Broadcast Products Technical Bulletin 20-2005-178

SUBJECT: **HIGH VOLTAGE DROPS WHEN HD SIGNAL IS CUT; NO PICTURE DUE TO PROTECTOR OPERATION**

MODEL: ***BVM-D9H1E***
BVM-D9H5A
BVM-D9H5E
BVM-D9H5U

Figure 1

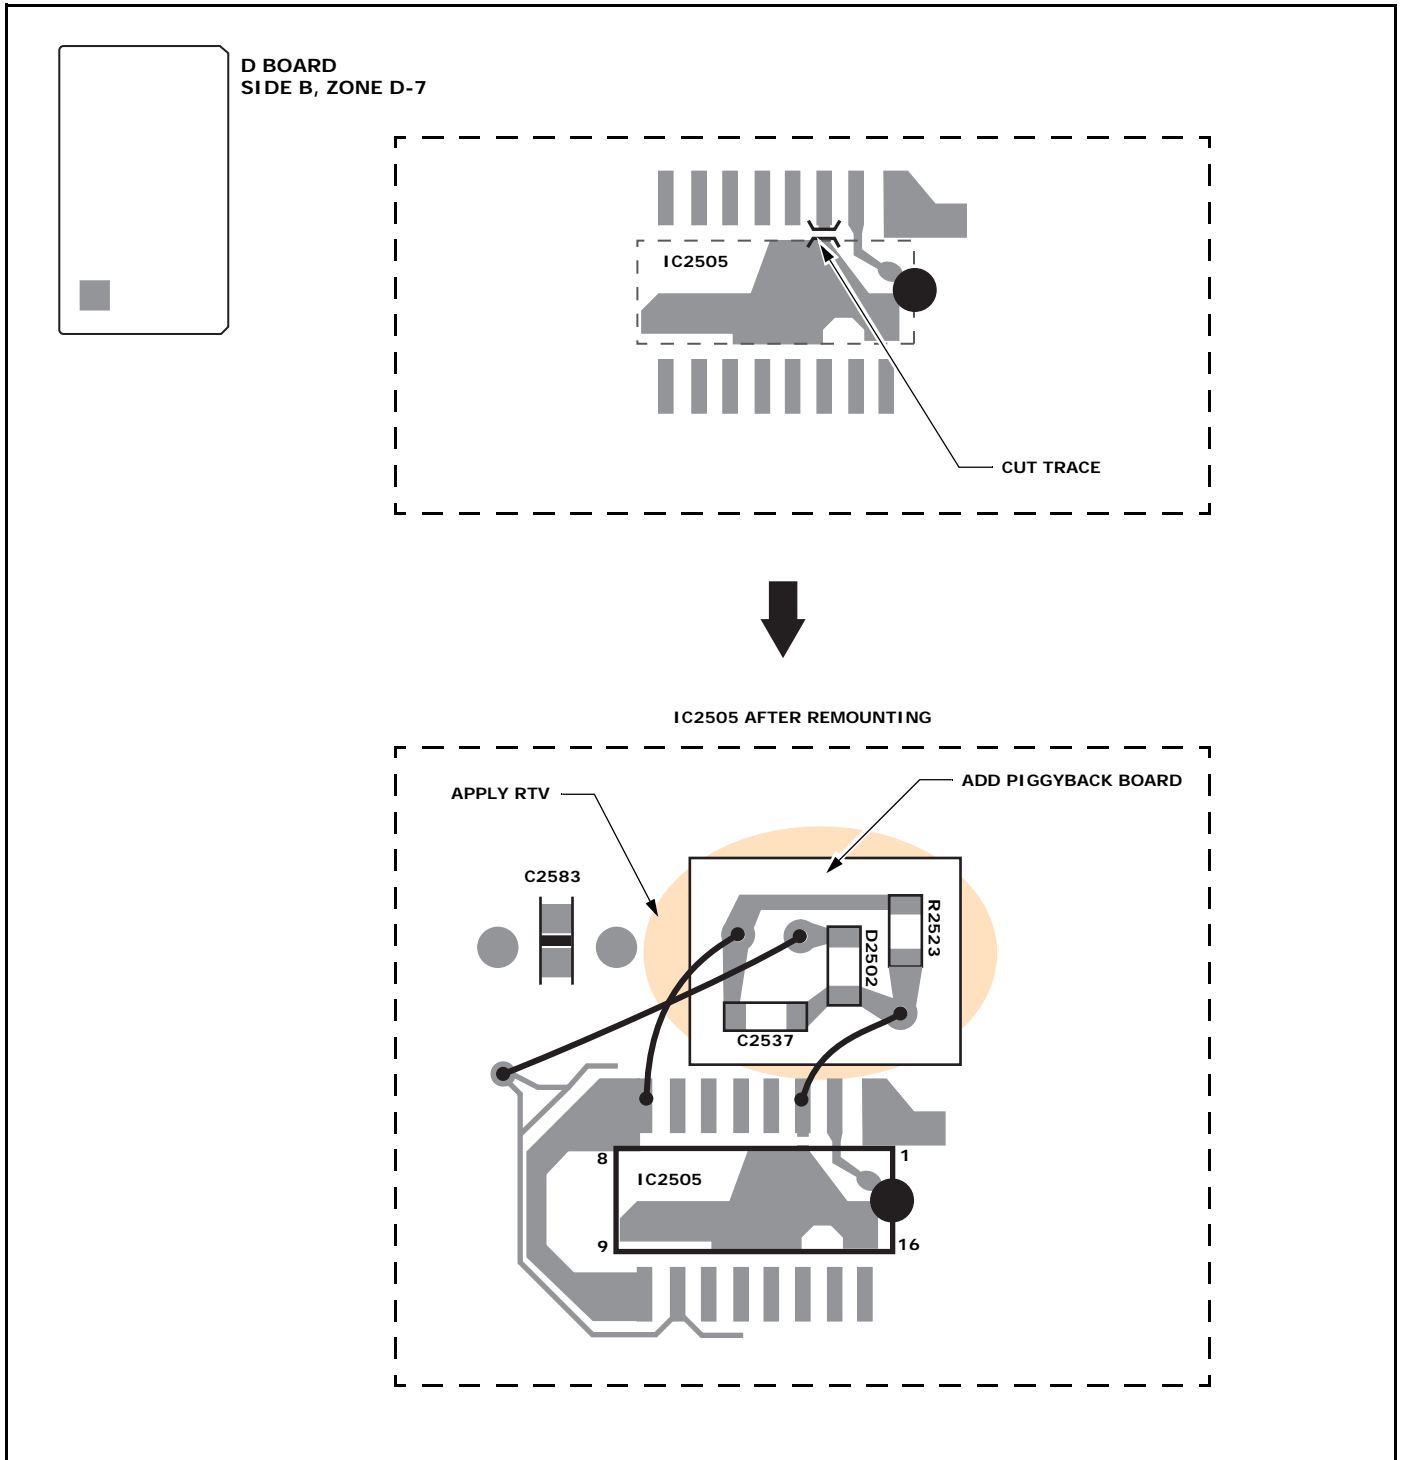
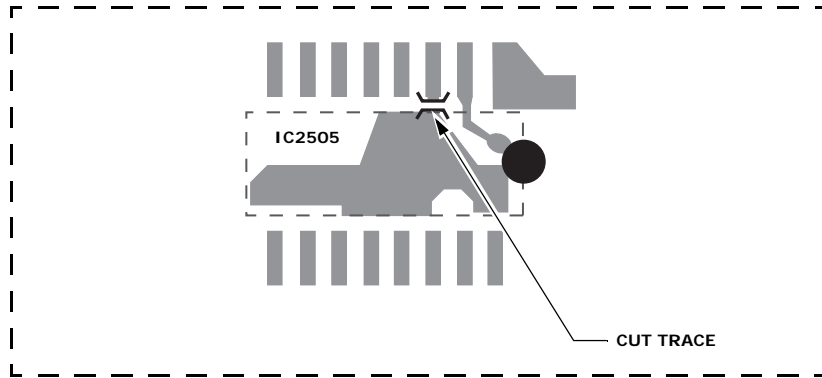
1. Remove C2632 (220 μ F), which is soldered in parallel with R2553 (zone B-6).

(See Figure 1.)

Figure 2

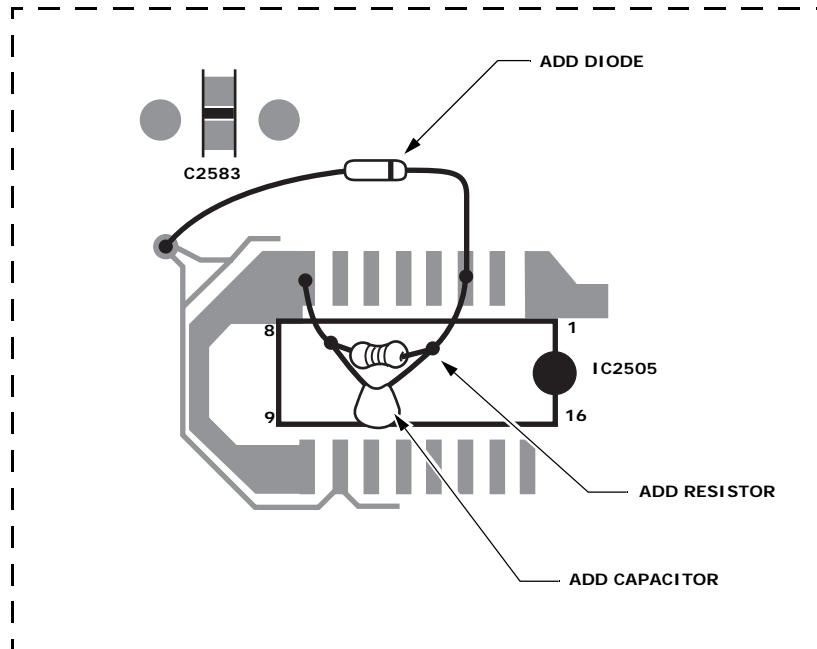
2. Modify the H SYNC circuit on the D board by adding a piggyback board as follows:
 - a. Remove IC2505 (zone D-7).
 - b. Cut the trace leading from IC2505 pin 3.
 - c. Replace IC2505 with a new IC (TC74HC4538AF).
 - d. Attach a piggyback board to the D board as shown in Figure.
 - e. Affix the piggyback board to the D board with RTV.

(See Figure 2.)
